APPLICATION NO.	FILING DATE	FIRST NAMED INVENTOR	ATTORNEY DOCKET NO.	CONFIRMATION NO.
10/550,811	07/27/2006	Kil-Wan Jan	2077-2 PCT US	3985

Office Action Summary	Application No. 10/550,811	Applicant(s) JAN ET AL.	
	Examiner ANDREW M. GILBERT	Art Unit 3767

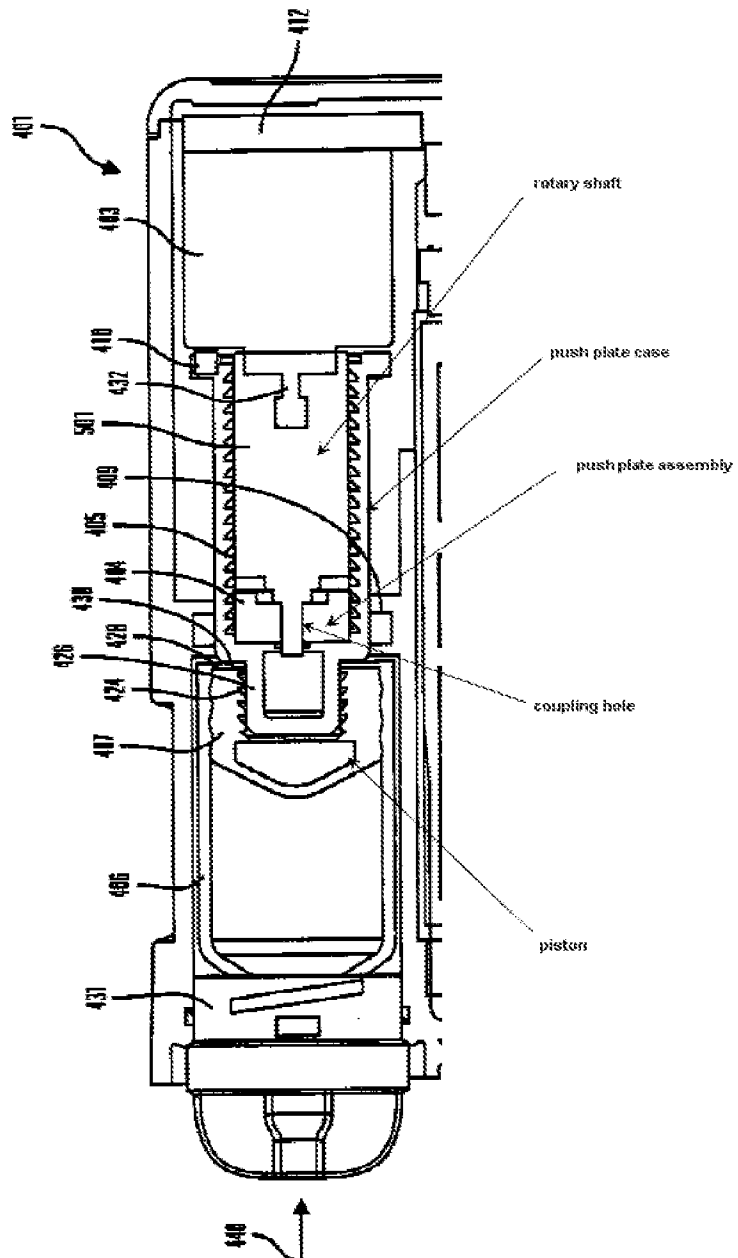
18. The applicant argues that the drive screw in McConnell includes a screw on the outer surface and fails to include a female screw formed on the inner circumferential surface thereof.

19. The Examiner directs the applicant to the following annotated Figure 4 of McConnell:

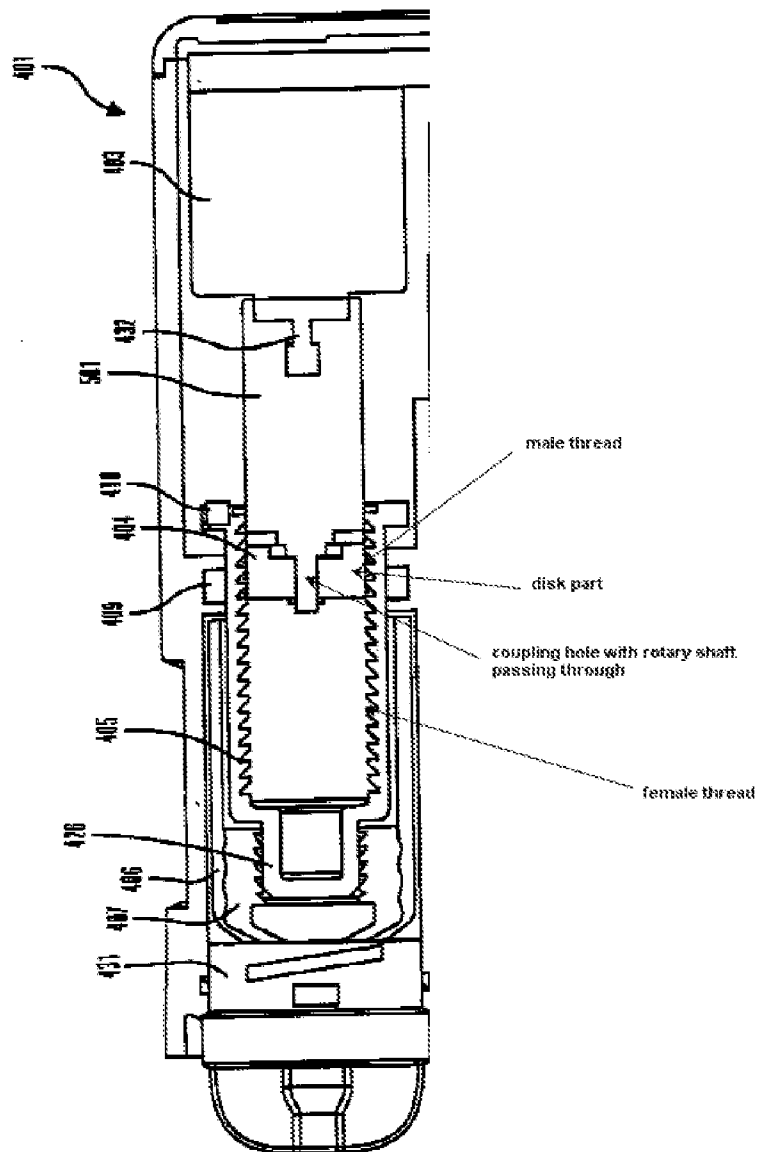
23. Thus, the Examiner notes that McConnell clearly discloses a female screw formed on the inner circumferential surface.
